FirstEnergy Nuclear Operating Company

Beaver Valley Power Station, Unit No. 1  
Docket No. 50-334, License No. DPR-66  
Completion of Required Action by NRC Order EA-12-051, Reliable Spent Fuel Pool Instrumentation (TAC No. MF0799)

NRC Requests for Information  
Page 1 of 39

**SECTION A-A**  
 AUXILIARY BUILDING  
 EL. 752'-6" & 735'-6"

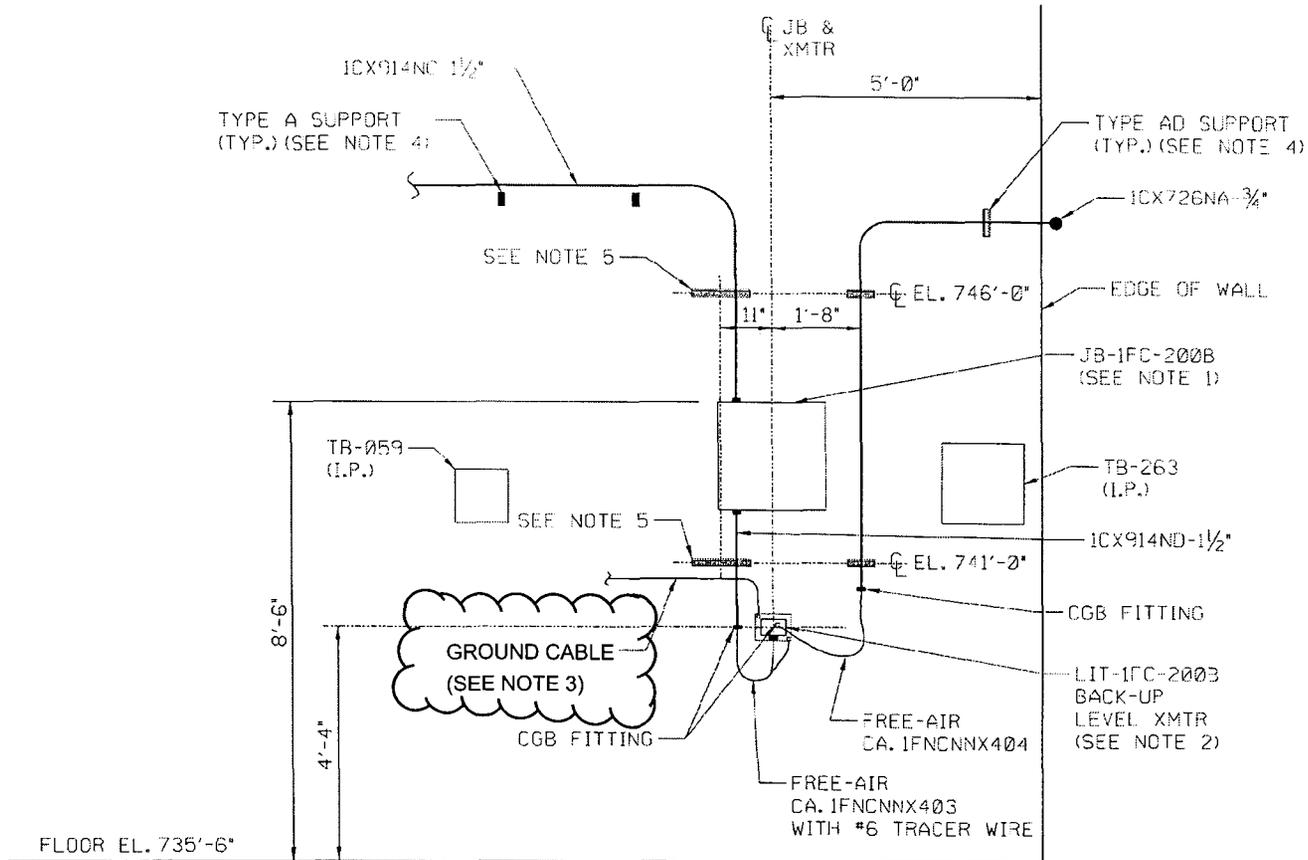
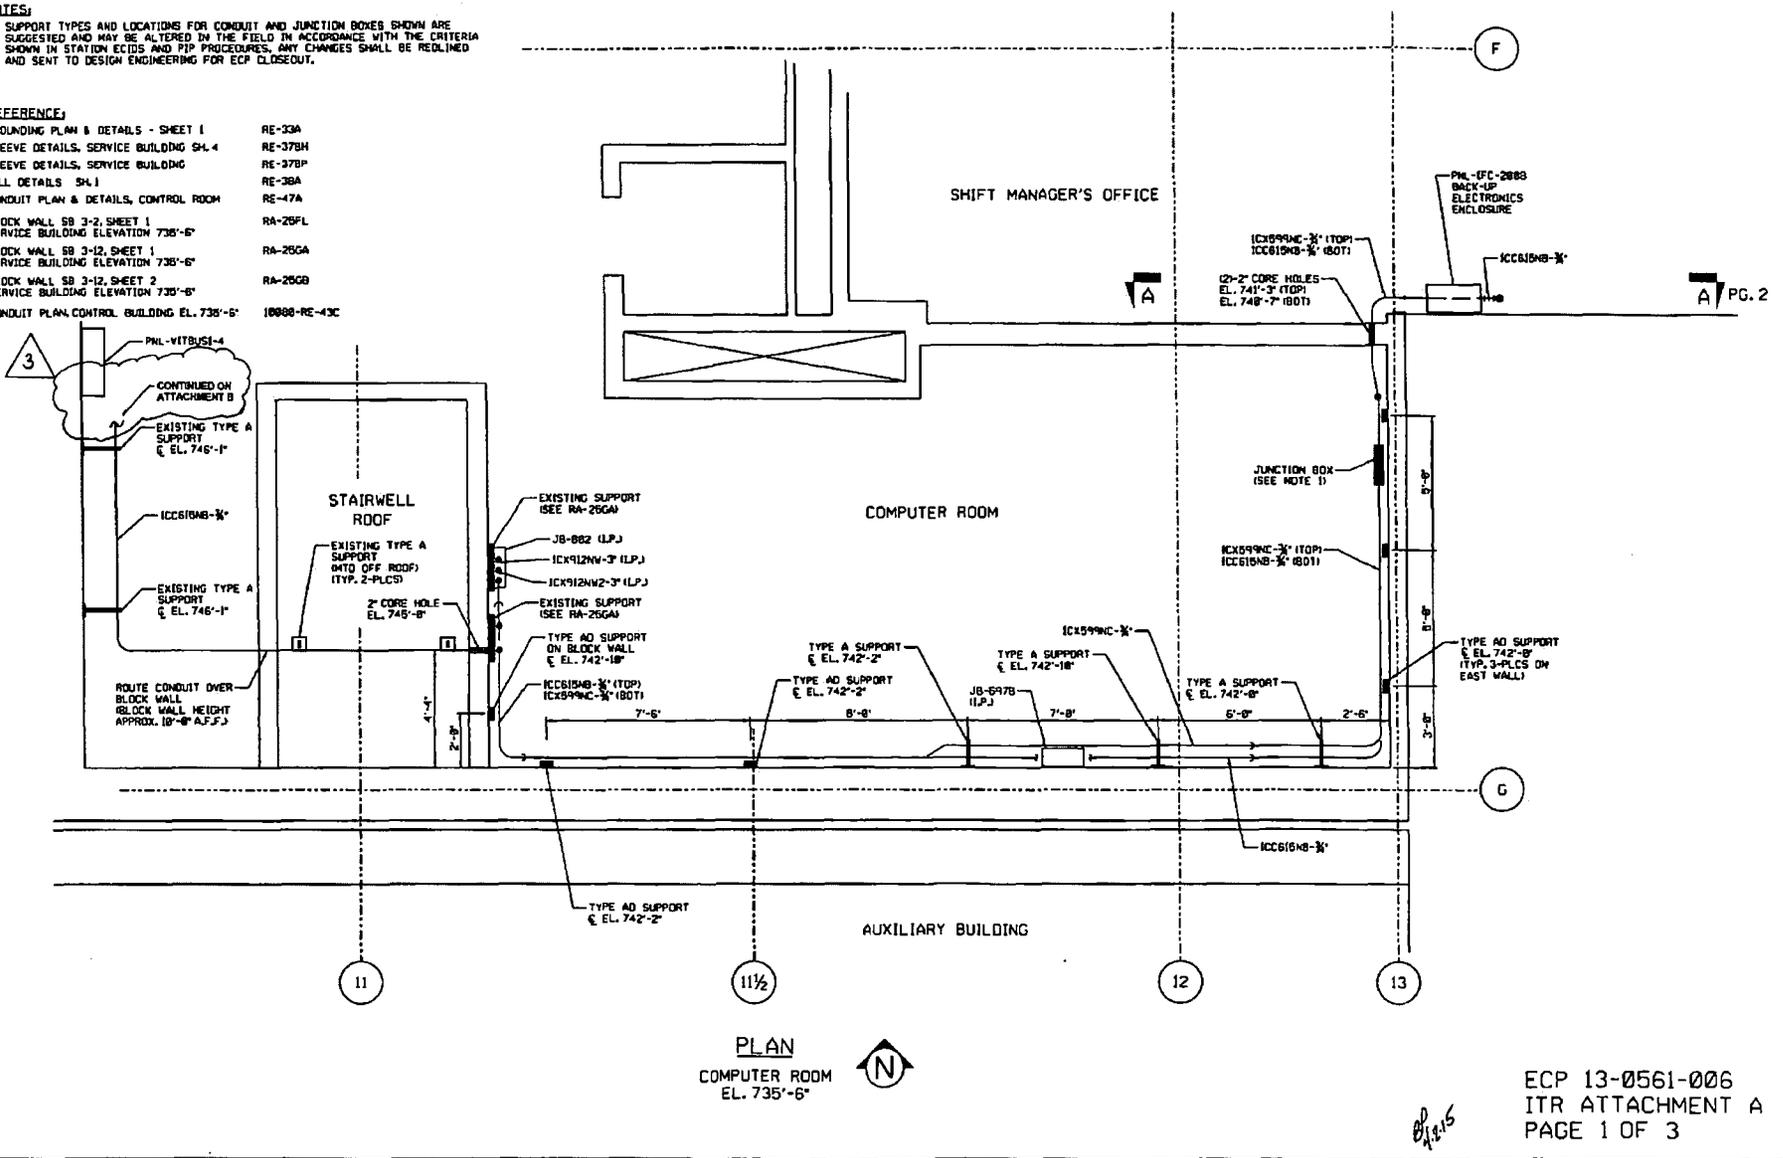
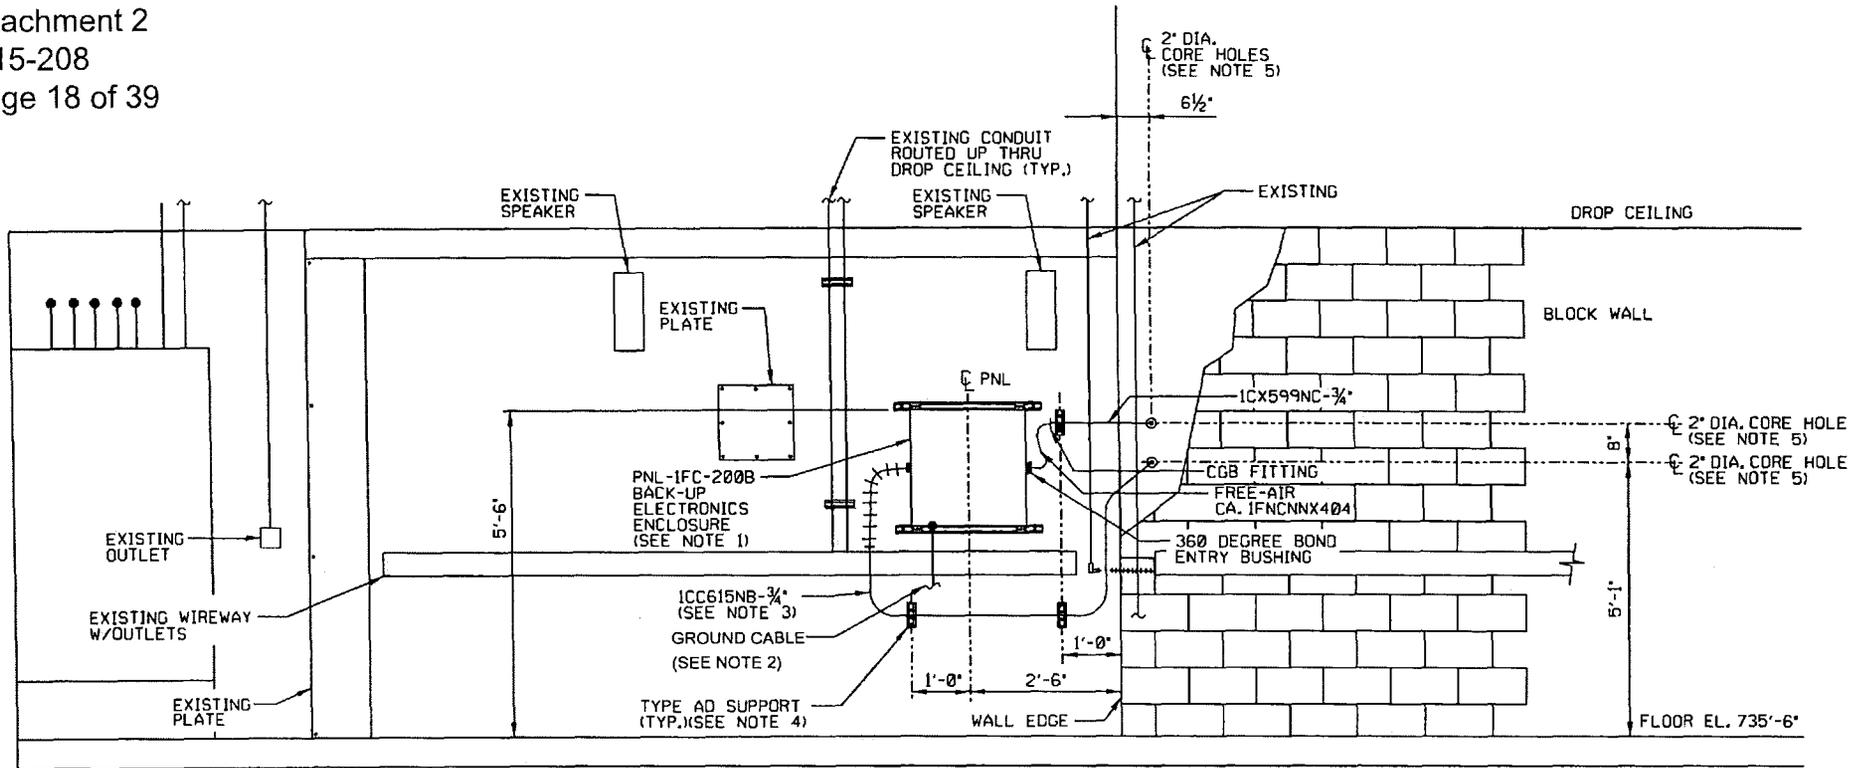
**Please provide a clearly labeled sketch or marked-up plant drawing of the plan view of the SFP [spent fuel pool] area, depicting the SFP inside dimensions, the planned locations/placement of the primary and back-up SFP level sensor, and the proposed routing of the cables that will extend from these sensors toward the location of the read-out/display device.**

The response to this RAI was provided by FENOC letter dated February 27, 2014. Subsequently, by FENOC letter dated February 26, 2015, the design for BVPS-1 progressed from conceptual design to final design. As a result, some of the locations of the instrumentation and conduit routing were changed. Updated sketches are provided below, depicting general configuration. Previous versions of these sketches were made available to the NRC staff for review.

The electronics enclosure units (transmitters) are located in an area removed from the SFP environment, which would be accessible in the event of a beyond-design-basis external event (BDBEE) that would restrict access to the SFP. The enclosures for the two instrument channels are separated to minimize the possibility of a single event damaging both channels. The primary level indicating transmitter LIT-1FC-200A is located on the west wall of the auxiliary building, general area elevation (El.) 735' 6", just east of the stairwell. The backup level indicating transmitter LIT-1FC-200B is located on the west wall of the auxiliary building, general area El. 735' 6", just east of the stairwell. The level transmitters located in the auxiliary building have a local display, although the credited display units will be located in the main control room (MCR). Cabling for each channel is run in separate conduits and cable trays to the control room indicators.

The primary electronics enclosure PNL-1FC-200A (control room analog indication) is located on the south wall of the old Shift Manager's Office in the control room, El. 735' 6". The backup electronics enclosure PNL-1FC-200B is also located on the south wall of the old Shift Manager's Office in the control room, El. 735' 6".
